Energy Provisions of CALGreen

Docket #15-CALG--01

**COMMENTS OF THE
LOCAL GOVERNMENT SUSTAINABLE ENERGY COALITION
ON
CALIFORNIA GREEN BUILDING CODES STANDARDS, 45 DAY LANGUAGE**

Figure 1. Potential Energy Reductions

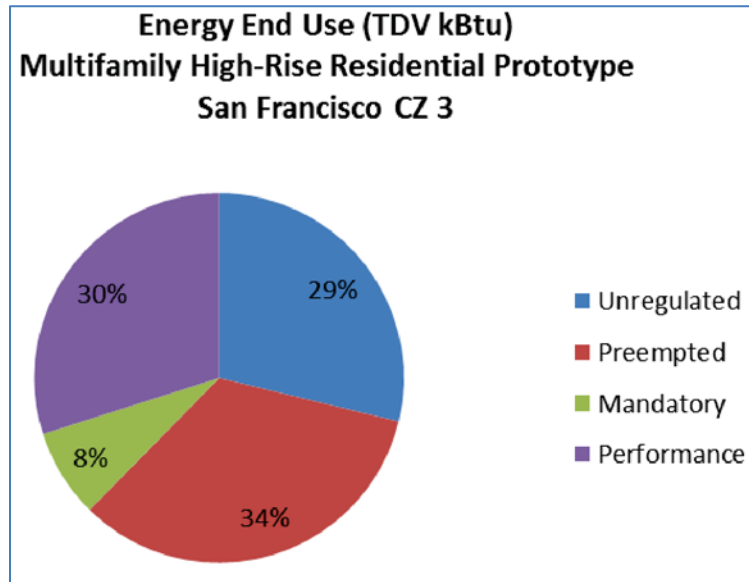
tradeoffs represent only 30% of expected total TDV energy consumption.² While the Energy Design Rating is an independent calculation, the percent-beyond-code approach to Tiers (and reach codes in general) has diminishing returns and diminishing practicality. A ZNE path based

upon the whole-building Energy Design Rating should afford maximum design flexibility (after compliance with the Energy Standards); as the Energy Standards grow more stringent, 30% savings from performance loads may not be the most practical, cost-effective, or programmatically desirable approach
